**K&A 578-95-01**

September 18, 1995

**SUBJECT:** Dixie Lime and Stone Company  
Sumterville Mine - Nonmetallic Mineral Processing Plant  
Air Construction/Operation Permit Application  
FDEP File Nos. AC60-275111, AO60-275112  
**Response to Request for Additional Information dated August 25, 1995**

PROCESS FLOW DIAGRAM  
CEDAR RAPIDS CRUSHER

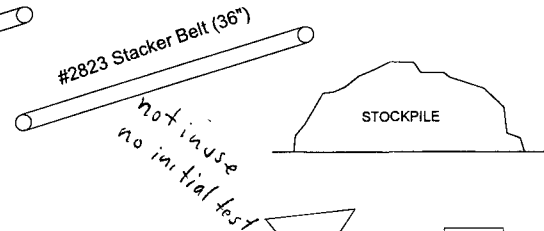
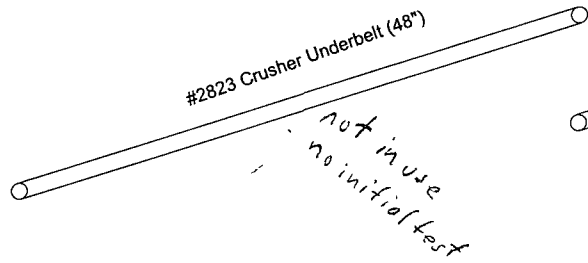
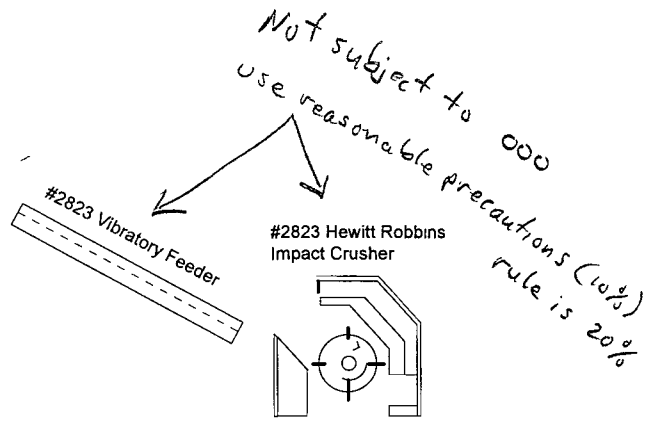
8. **Identify in the process flow diagram, by unique designation, each piece of equipment listed.**

Revised process flow diagrams are included as Attachment 2.

PROCESS FLOW DIAGRAM  
STORAGE BIN

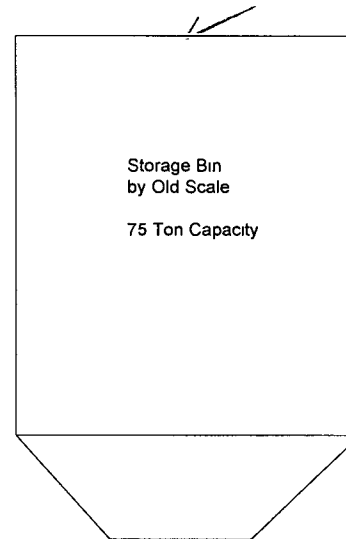
9. **Please identify the storage bin in the process flow diagram.**

The storage bin is separate from the portable crushing units. A process flow diagram for the storage bin and associated conveyors is included with Attachment 2.
